DOCKET NUMBER *
PROD. & UTIL. FAC. 50-160-REN + OM
50-160 (2.206)

To: The Executive Director of the NRC and
Commissioners for the NRC
Atomic Safety and Licensing Board Justices
Bachmefer, Kline and Lam,
and the entire Service List on the response to my 2.206 Petition dated July 21st, 1995 concerning
the Georgia Tech Reactor, Docket 50-160 and other issues I raised.
U.S. NRC,
Washington, D.C. 20555

Aug 18th, 1995

▲ APPROX IMAGE,
REACTOR
LOCATION
(I ADDED THE
TRIANGLE)

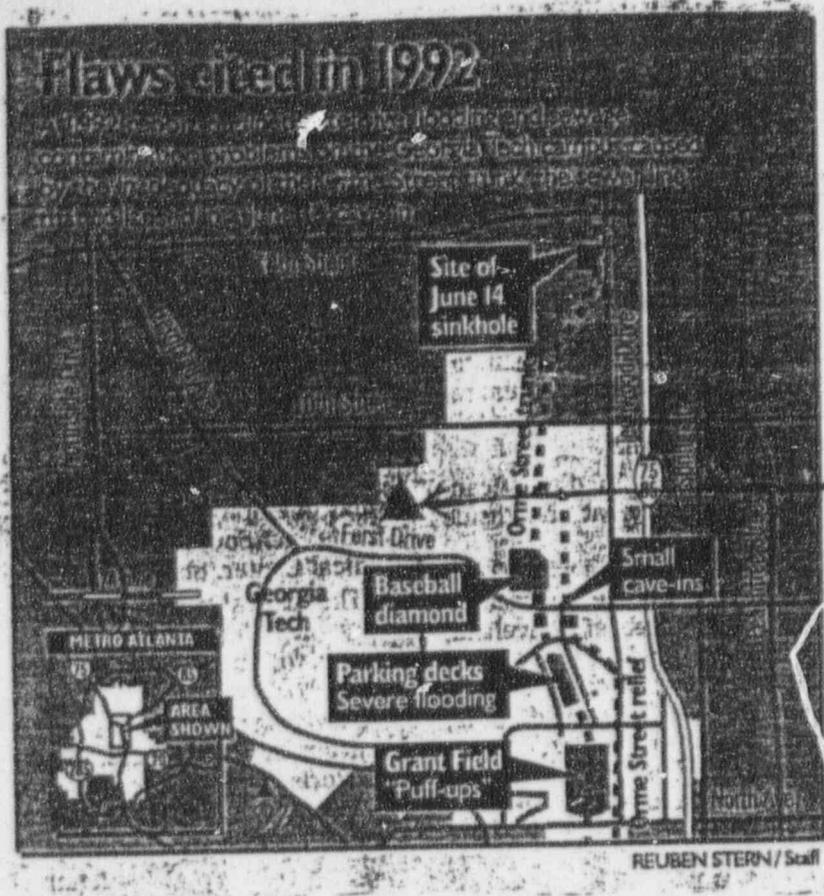
p. 27 I gave NRC a great deal of data on the geological problems and referenced the attached article (1992 Study Warned of Cave Ins , sewer under Tech campus inadequate city was told") in my first letter to NRC under the Petition. I also maintained that in the SAR, the actual geology is not site specific, plus it shows it was put in an unstable location over an old drainage path on fill (SAR pages 17,22,23.)
